South Texas Project Electric Generating Station P.O. Box 289 Wadsworth, Texas 77483

June 30, 2015
NOC-AE-15003270
10 CFR 54
STI: 34151048
File: G25

South Texas Project
Units 1 and 2
Docket Nos. STN 50-498, STN 50-499
Response to Requests for Additional Information for the
Review of the South Texas Project, Units 1 and 2,
License Renewal Application – Set 28 (TAC Nos. ME4936 and ME4937)

SOUTH TEXAS PROJECT, UNITS 1 AND 2
REQUEST FOR ADDITIONAL INFORMATION, SET 28
(TAC NOS. ME4936 AND ME4937)

Figure 2-1: Lower Radial Support Comparison

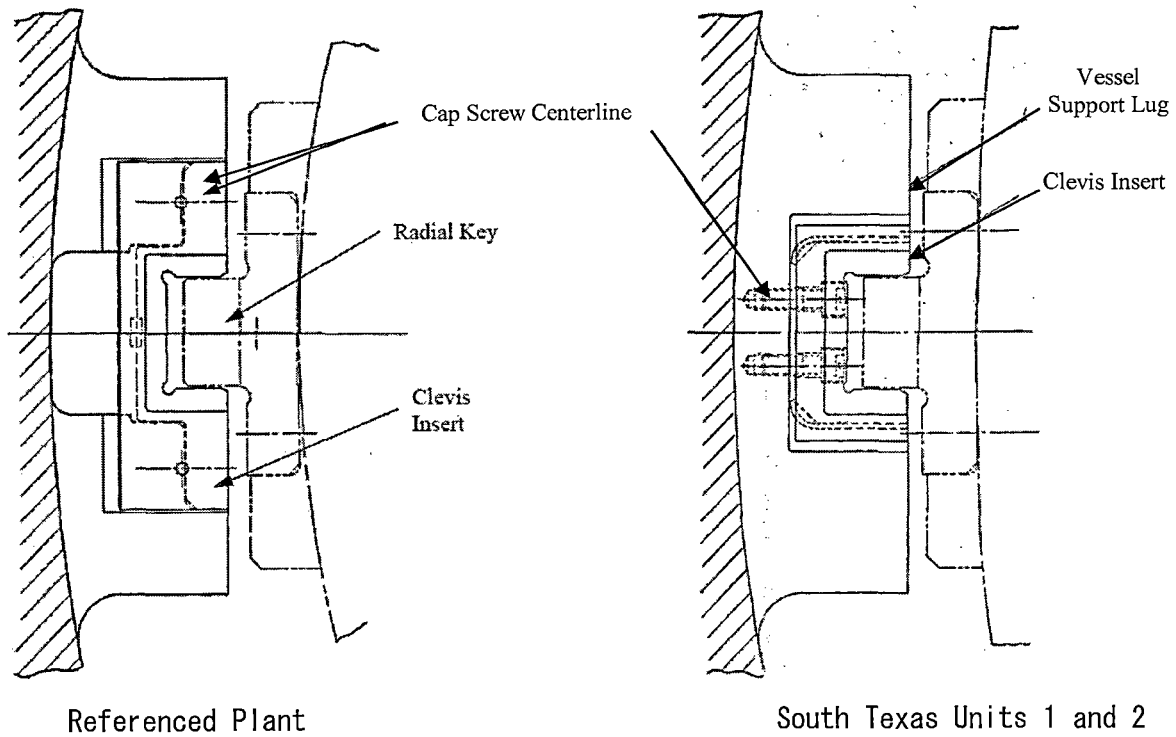
2. Reactor vessel clevis assemblies: Please address the clevis insert bolt operating experience issue cited above in reference to STP:
 - a) Describe the configuration of clevis insert assemblies at STP, including number of bolts in the assemblies. Specify the materials of fabrication, including any applicable heat treatments that were used for the design of the clevis insert bolts at STP.

- b) Discuss and justify whether the operating experience associated with cracking of the clevis insert bolts is applicable to the clevis insert assembly designs at STP.

- c) Describe the inspections that have been performed of the clevis insert bolts, including the type of inspection (e.g., VT-3). Discuss the visual inspection coverage that was achieved during these inspections. Clarify the ASME examination category that applies to inspections of the clevis insert bolts (and identify the applicable inspection method and frequency) and whether any past examinations have resulted in the detection of any indications of cracking or failures of the clevis insert bolts that are included in the clevis insert assembly designs. If so, provide the details of the inspection results and clarify the corrective actions that were taken at the facility to justify the structural integrity of the clevis insert assemblies and the intended safety function of the plant's core support structure and its components during plant operations.

- d) Based on your responses to Parts (a) through (c) of this request, clarify whether the 10-year ISI basis (or the current approach used for STP) for the clevis insert bolts is sufficient to manage cracking and wear of the bolts during the period of extended operation. Justify your response to this request.

- (a) The clevis insert assemblies at South Texas Units 1 and 2 are comprised of eight clevis insert cap screws fabricated from Inconel® X-750, SA-637, Grade 688, Type 2, two dowel pins fabricated from Alloy 600 and an Alloy 600 hard-faced U-shaped clevis insert that rests onto the clevis locations in the reactor vessel. In total there are six clevis locations (0, 60, 120, 180, 240 and 300 degrees). The clevis insert cap screws include a lock bar that is welded to the clevis insert face. The clevis insert cap screws are attached to the interior face of the clevis insert assembly. See Figure 2-1 for a comparison of the clevis insert assemblies for STP and the reference plant that had clevis insert cap screw cracking.

The South Texas material used for the clevis insert cap screws is similar to that used by the operating experience referenced plant where cracking was observed. The reference plant cap screw material heat treatment consisted of equalization heat treatment followed by a one-hour solution heat treatment. The precipitation hardening temperatures are the same, but the cooling time between temperatures for the reference plant is longer. For either type of heat treatment, susceptibility to primary water stress corrosion cracking is known to exist. STP specific heat treatment values for the above methods are Westinghouse proprietary information but can be made available upon request. The cap screws are of the same design, except that the South Texas cap screw shank length is slightly longer. The cap screws were installed with the same torque as that used for the referenced plant.

- (b) The main function of the Lower Radial Support System (LRSS) is to prevent tangential or rotational motion of the lower internals assembly while permitting axial displacement and differential radial expansion. These supports are designed to prevent excessive lateral and rotational displacement of the lower internals during seismic and loss-of coolant accident (LOCA) conditions. The supports also limit displacements and misalignments in order to avoid overstressing the core barrel and to ensure that the control rods can be freely inserted. Therefore, assuming the clevis inserts remain in place as limited by the adjoining radial keys and support lugs, the design function of the LRSS will be maintained during seismic and LOCA conditions.

South Texas Units 1 and 2 have six radial supports spaced at 60-degree intervals around the circumference of the vessel. Although labeled as radial supports, the supports actually support the core barrel only in the tangential direction because the tangential clearances between the core barrel keys and the vessel clevis inserts are much smaller than the radial clearances. This basic arrangement is the same for South Texas units and the reference plant where clevis insert cap screw cracking was observed; however, the clevis insert designs are different. See Figure 2-1 for this comparison. The same number of eight cap screws is arranged in the same two vertical columns of four cap screws each. Two interference-fit dowel pins of the same size are located in-line with the cap screws in the same manner as the reference plant. The main design difference is that the South Texas reactor clevis insert is U-shaped, with the cap screws located inboard of the "U"; whereas the reference plant insert, while also being U-shaped, has flanges on either side where the cap screws are located. The tangential interference fit of the insert against the support lug is at the ends of these flanges for the reference plant design and on the sides of the "U" for the South Texas reactor design. Therefore, the tangential interference-fit compression stiffness of the two inserts is different.

The clevis insert cap screws for the South Texas units are of a similar design, of the same material with very similar heat treatment, torqued to the same degree, and operated at a slightly hotter T_{cold} inlet temperature as compared to the reference plant, it is possible that these cap screws can experience primary water stress corrosion cracking (PWSCC) similar to that of the reference plant. Therefore, the operating experience relative to cracked clevis insert cap screws is applicable to South Texas units.

The clevis insert, if completely loose to slide radially inward, is captured in a manner similar to the reference plant and is restrained by a similar radial gap before it contacts the radial key. With the clevis insert displaced fully inward, the primary stresses on the clevis support lugs remain acceptable relative to the reactor vessel original ASME 1971 Edition (through 1973 Summer Addenda) code of construction under plant-specific maximum upset and faulted condition loads due to seismic and LOCA conditions.

The increase in insert stress due to broken cap screws remains acceptable because the fatigue analysis maintains an acceptable usage factor less than 1.0.

The insert cap screws have the same head design and locking device design as the reference plant. A lock bar is installed in a groove in the cap screw head, and the bar is welded to the insert counterbore where the cap screw is inserted. If a cap screw head should separate, the lock bar can wear and separate over time, causing the cap screw head to be loose in the counterbore recess. The maximum design gaps between the core barrel radial keys and the inserts are less than the height of the cap screw heads. Therefore, the cap screw heads remain captured, unless, over a long period of time, wear of the heads reduces the height of the heads by this amount. The cap screw head wear is expected to be small because the cap screw material is much harder than the clevis insert and radial key material.

Existing inspections are already in place to account for this concern. Qualified personnel at South Texas performing video camera inspections at 10-year intervals, as specified in ASME Code Section XI and MRP-227-A, are capable of identifying wear or dislodged components of the clevis insert cap screws or dowel pins at any location.

Visual inspection at 10-year intervals can also detect wear and displacement of the clevis insert. Inspection of the insert and key contact surfaces can detect wear in adjacent non-contact surfaces. If cap screw heads are observed to be loose, any displacement of the insert relative to the vessel support lug can be easily observed. During the last in-service inspections at the South Texas units in 2010, no indications of loosening or adverse wear were observed. Based on the above considerations and observations, it is concluded that the current in-service inspections to examine the clevis insert (and LRSS) with VT-3 is adequate without augmentation.
